- I. Background/Overview:** Andrew Hadley and Kyle Ryan submitted an application on behalf of the Augusta Park Partners LLC for plans to construct a new single-family residence and a cold accessory building located at 31 Augusta Drive.
- II. Status:** The Applicants met with the DRC at the 12/8/25 meeting. Notes from the meeting are attached for more detailed information.

**V. Land Use Code Review:
Residential Zone District (R1F) (Sec. 16-4-1000-16-4-1060)**

Augusta Park - T4

Proposed Site plan

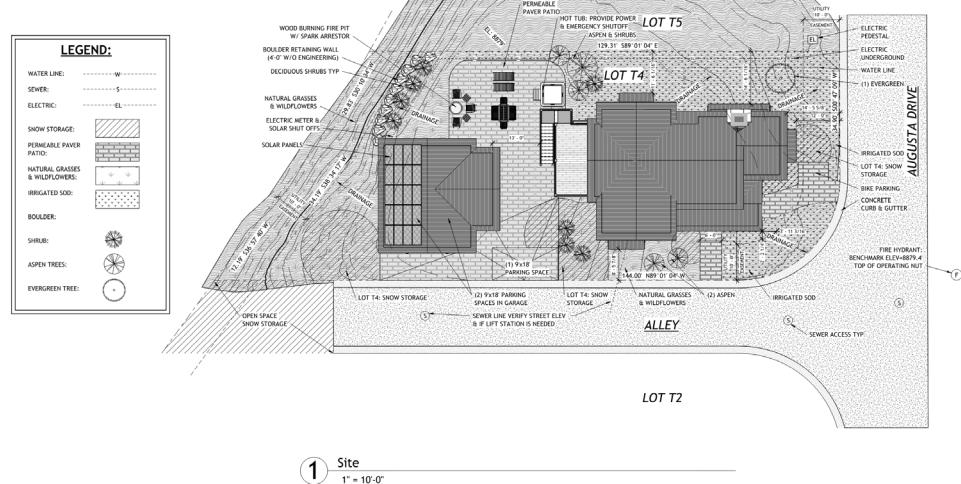
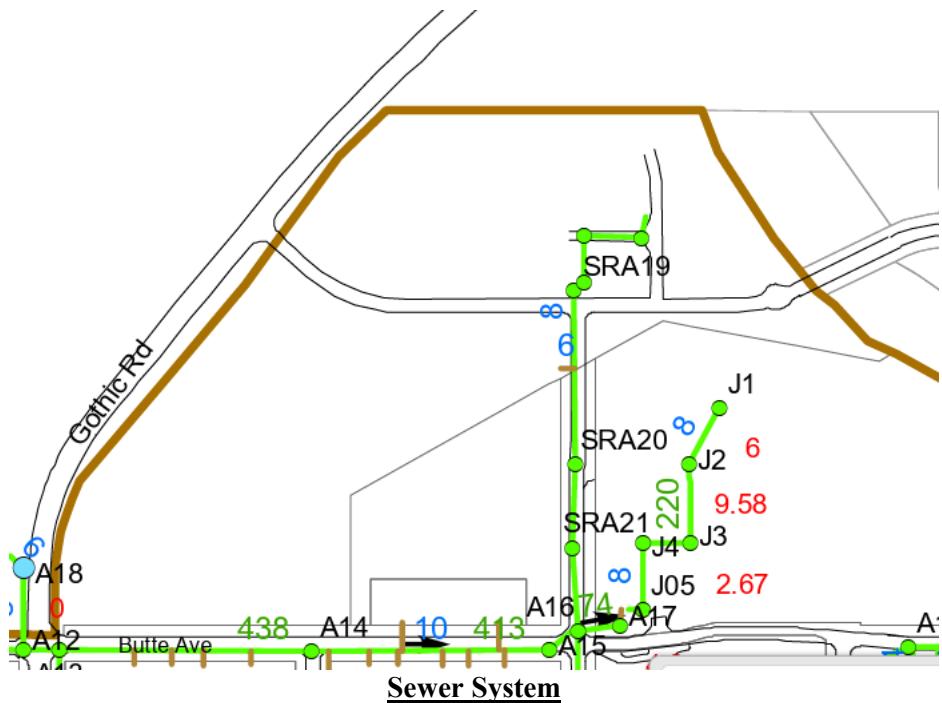
GL	Staff Analysis	DRC Recommendation
Topography	<p>On the northeast corner of the lot, the grade is noted 8875'. This transitions up to 8878' and then back down to 8870' in the southwest corner of the lot.</p> <p>Over the course of the primary building footprint, the grade is 8878'3", which is the elevation used for measuring FAR.</p> <p>For the accessory, the bulk of the grade for measuring FAR is 8877'.</p>	Support

2.8 Drainage	Drainage arrows for the site are shown. With the inclusion of the basement, a dry well onsite will likely be required, but details for this can be coordinated prior to permitting.	Support
Easements	<p>There is a 10' utility easement for the west side and for the east side of the lot. Both are called out on the site plan, as well as a 10' utility easement on the southeastern corner.</p> <p>The trees have been removed from the utility easement on the southeast corner.</p>	Support

2.19 New trees	There is one evergreen noted for the north and slightly east portion of the	12/8 DRC: Shift trees out of easement area. This has been done. Support

- make sure to include natural grade lines on site plan
- Permeable pavers called out on site plan but perhaps an area for Board discussion
- Trees to be removed from southeast corner easement

- Accessory windows to be updated as divided lite
- New site plan: moved primary building to east 8' to put it 12' feet off of Augusta
- pulled garage 5' feet east (which will help with the height of the accessory)

- House & Garage shifted east on site.
- Pavers reduced.
- Trees shifted from easement area.

- Added WUI code note to our Notes page.
- Pushed the shrubs & trees away from the structures.
- The patio plan has had further development that will better illustrate how it will be used. This includes some furniture as well as a hot tub.
- Added some exterior lighting above the back deck & some additional notes for lighting below roofs at walkways.
- Inclusion of heights for AB as it relates to natural grade.

Accessory building mass/scale/form and placement (garage): Refer to GL 4.84-4.86, 4.89;

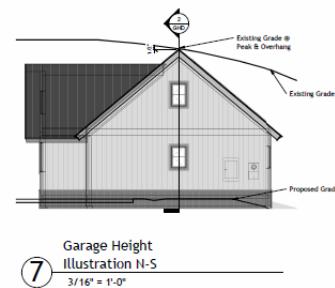
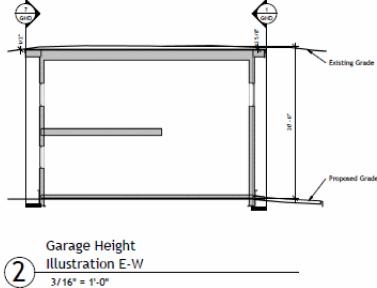
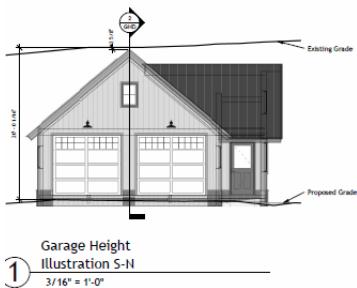
The proposed accessory building is a 24'x28' gable module. Then, there is a 6'x14' gable module to the east. The main module has a 10:12 pitch with a 10:12 gable roof on the east. This must be a cold building due to the size, as proposed.

GL	Staff Analysis	DRC Recommendation
4.84 Smaller in size	The proposed building is smaller in scale than the primary building, as requested by the GL.	
4.85 Rear of the site	This building is located on the west, which is the rear of the lot. Meets GL.	
4.86 Vary appearance	This is the third accessory building within this zone. The proposed accessory appears to vary in appearance to the prior proposed accessory in the neighborhood.	
4.89 d. porches	There is a small covered porch on the south. Support.

Garage Height Detail

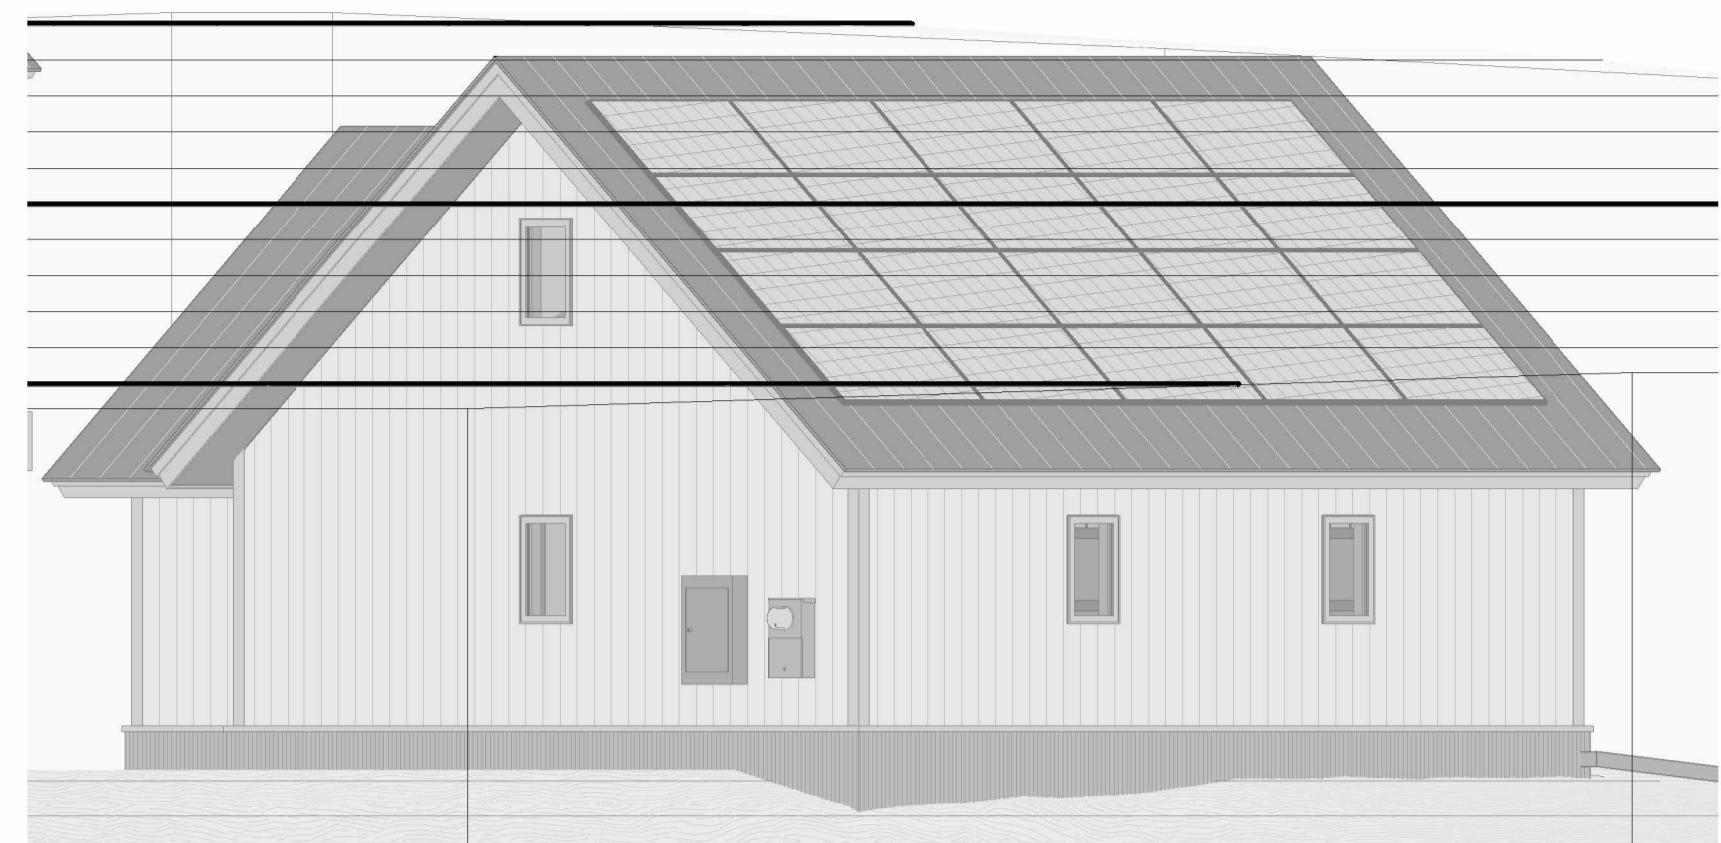
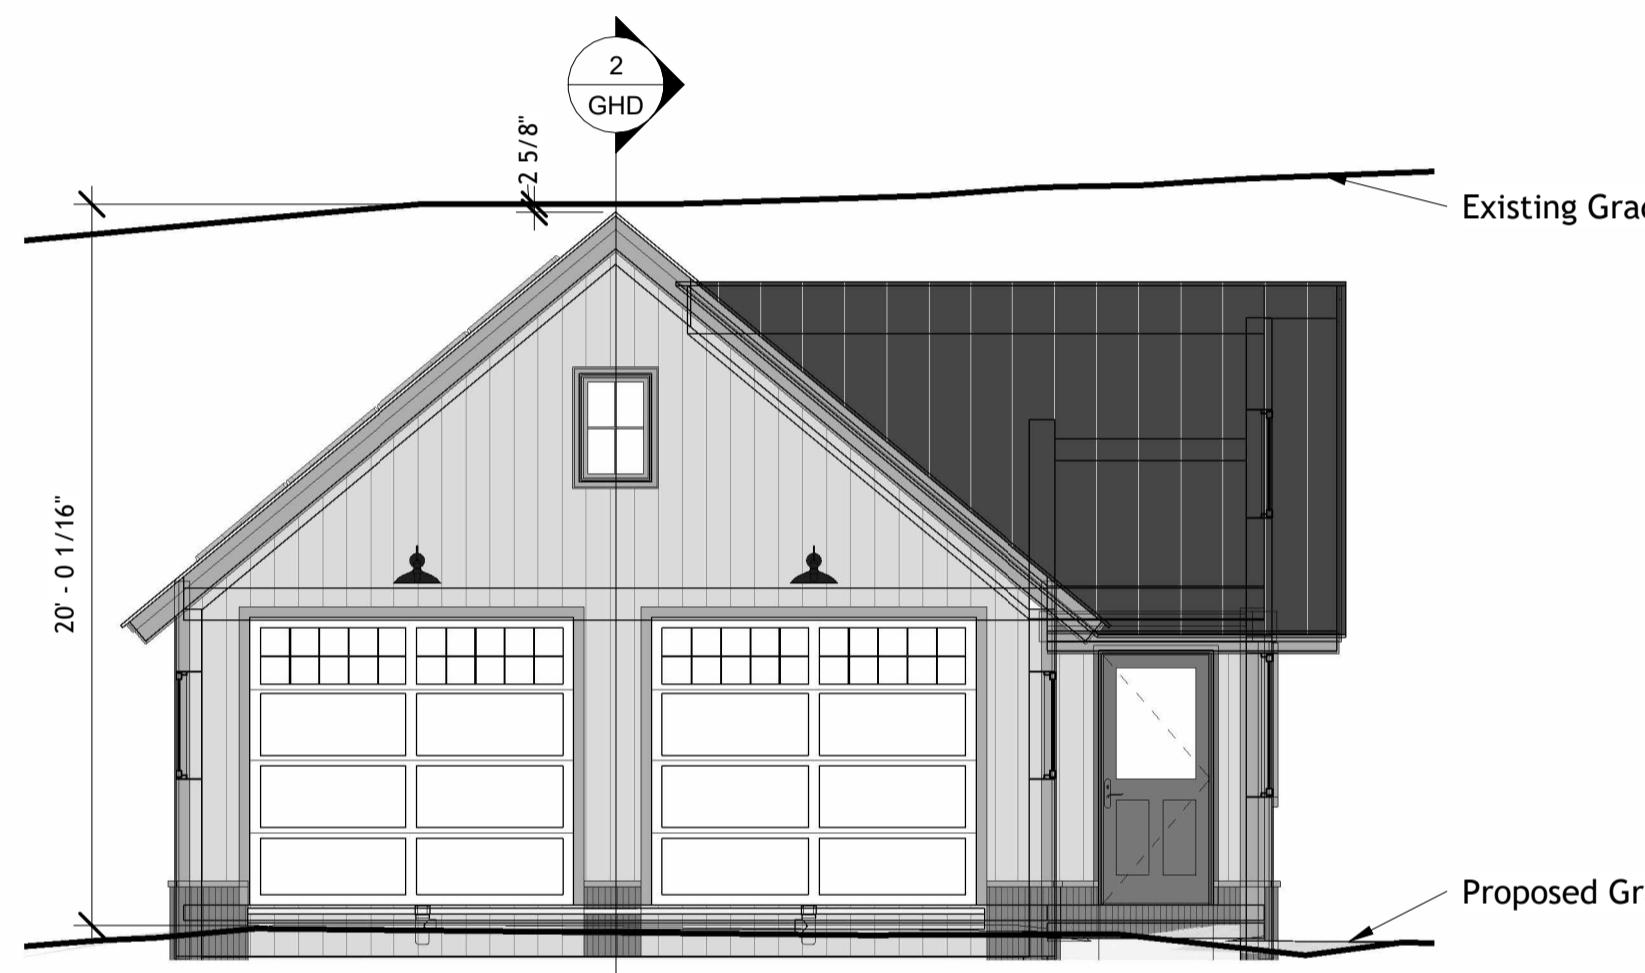
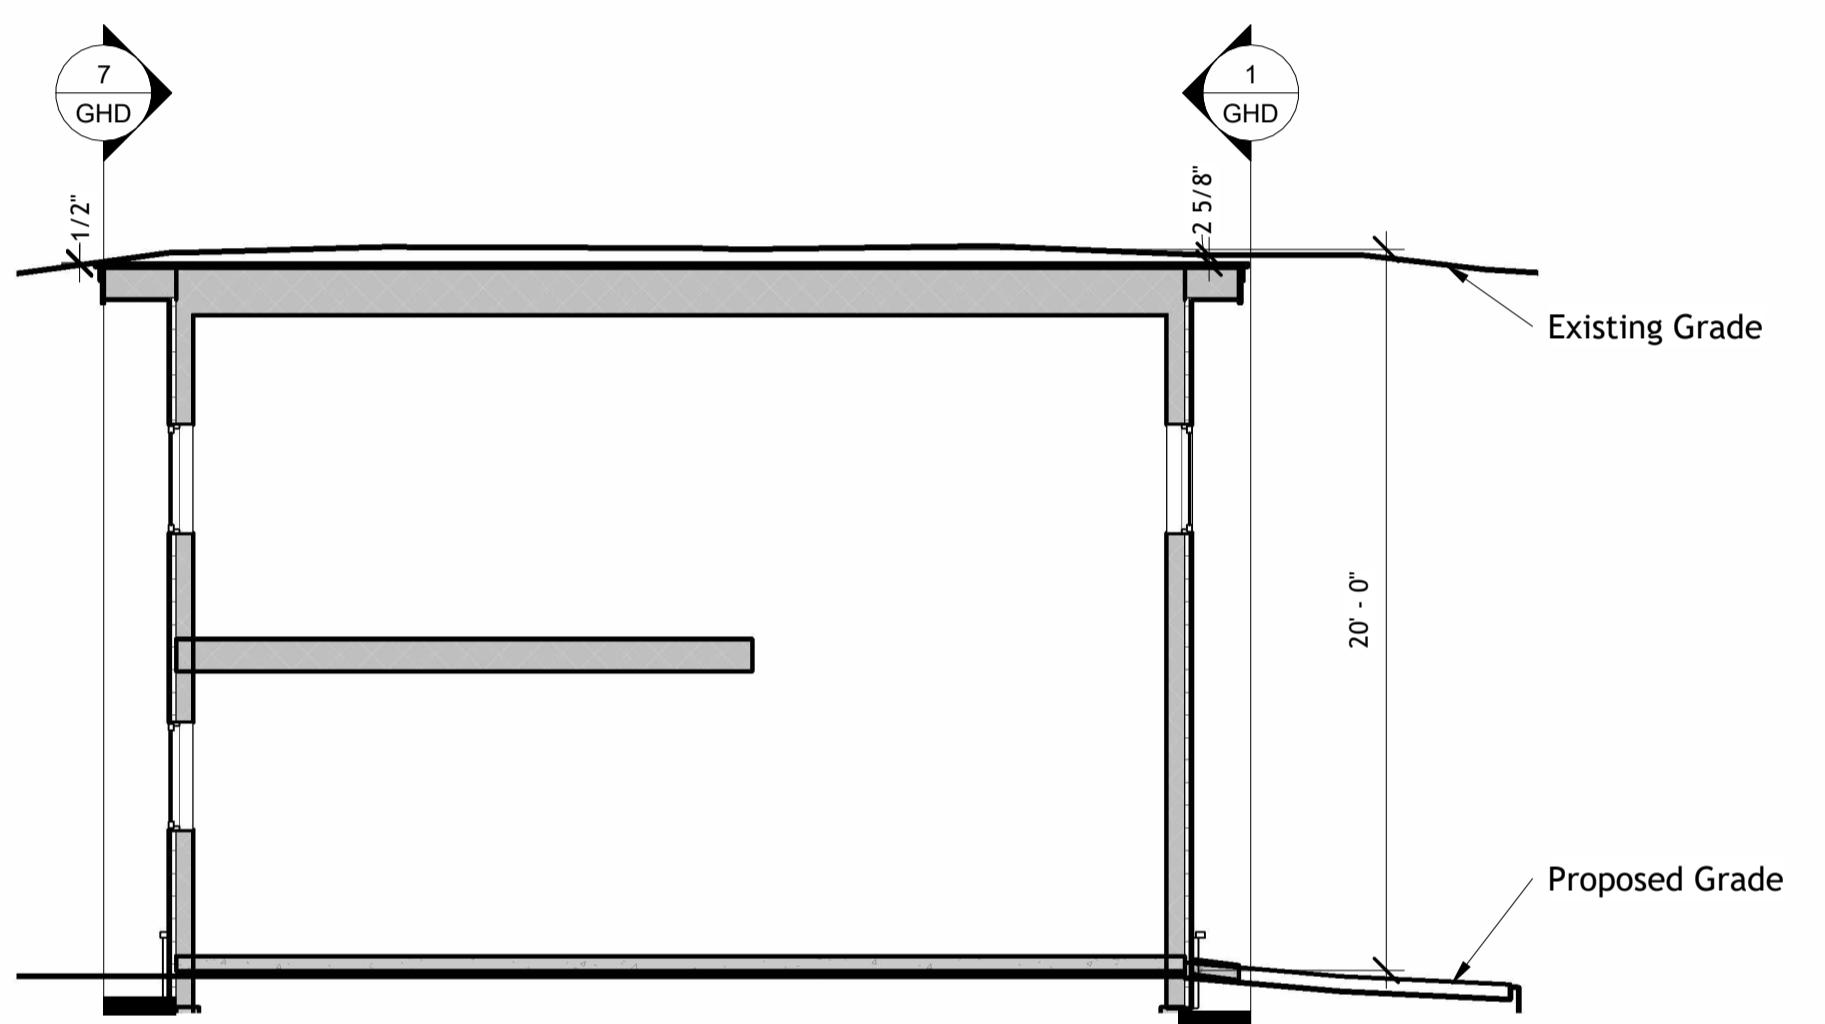
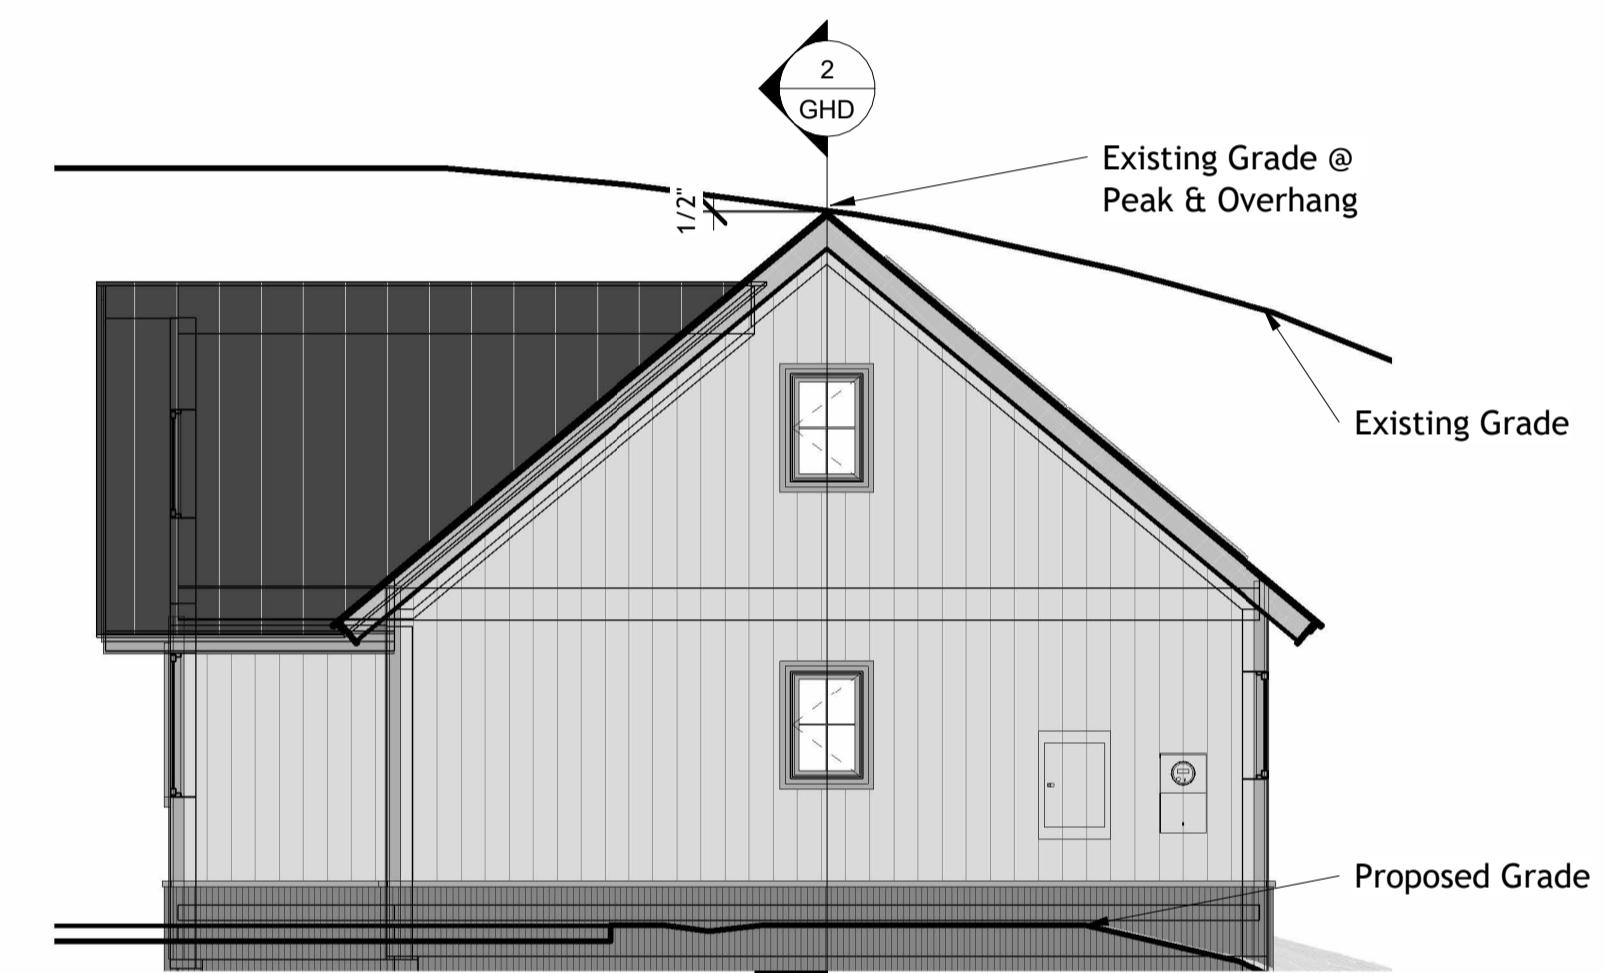
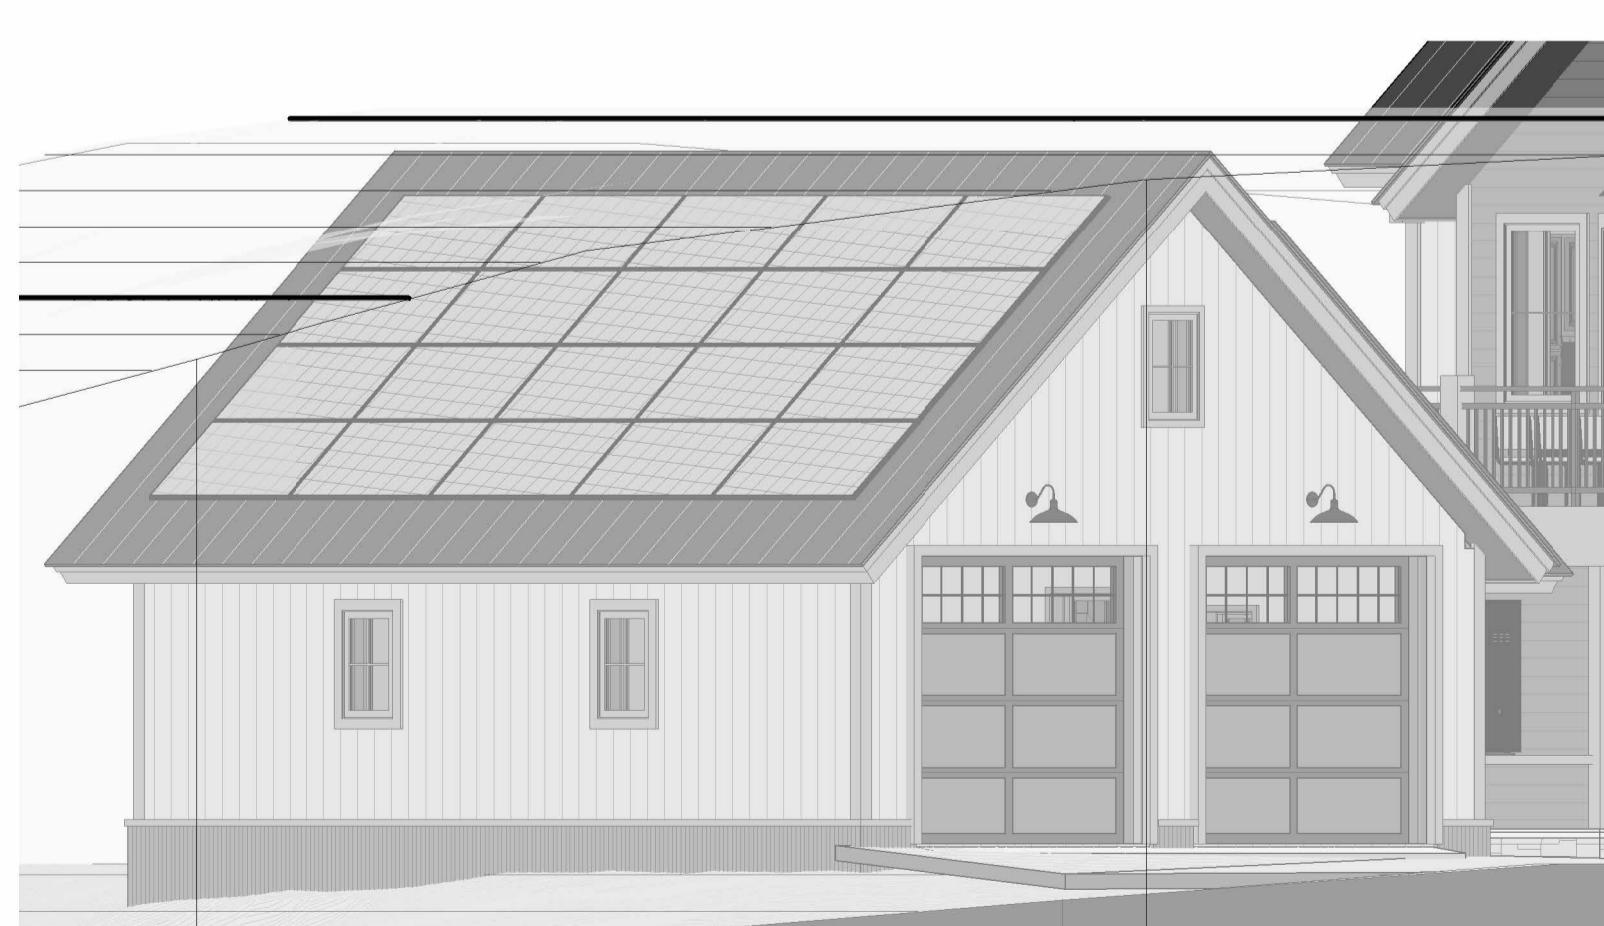
AB: Foundation cover height was discussed and it could be supported because it was not street facing.

Hadley and Ryan walked through the site plan and elevations to explain revisions. The height of the AB will be looked at. They pulled up the east ridge and the north/south ridge came down slightly to respond to December DRC's concerns. Chimney was pulled out 6" per comments from December DRC. The pavers changes a little and were reduced.
